MANDATORY SERVICE BULLETIN

DATE: October 30, 2006 Service Bulletin No. 572
Engineering Aspects are
FAA Approved

SUBJECT: Missing Oil Passage Hole at Idler Shaft Location

Figure 1.

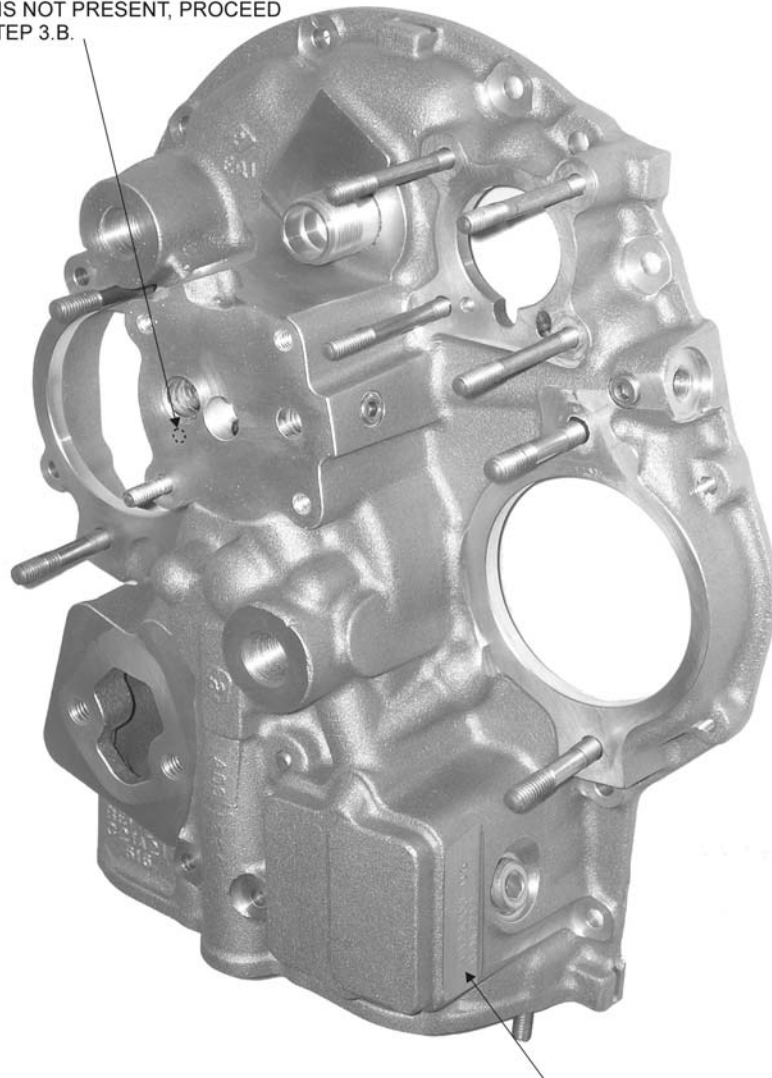
3. If the serial number contains "7212", then followed by the four numbers 0001 thru and including 0060, proceed with the following steps:
 - a. Remove the oil filter base or pressure screen housing and inspect for the presence of a 3/16-inch hole at the location shown in Figure 1.

THE OIL PASSAGE HOLE CAN BE FOUND NEAR THIS LOCATION. IF THIS IS NOT PRESENT, PROCEED WITH STEP 3.B.

THE ACCESSORY HOUSING SERIAL NUMBER WILL BE STAMPED HERE. IF THE SERIAL NUMBER DOES NOT CONTAIN "7212" THEN NO FURTHER ACTION IS REQUIRED. IF IT DOES CONTAIN "7212" THEN PROCEED WITH STEP 3.

- b. If the 3/16-inch hole is not present, contact an authorized Lycoming distributor for further instructions regarding warranty part replacement.
 - c. If the 3/16-inch hole is present, verify that it passes through to the interior of the accessory housing by using compressed air or probing with a thin piece of wire.

- (1) If compressed air is used and no obstructions are present, then there will be an audible sound of air escaping into the interior of the accessory housing.
 - (2) If a probe is used, no obstructions will be encountered before a minimum insertion depth of 2.324 inches.
- d. If no obstructions are found, no further action is required.
 - e. If the passage hole is obstructed, contact an authorized Lycoming distributor for further instructions regarding warranty part replacement.
4. Warranty part replacement is available for a period of one year from the date of this Service Bulletin.
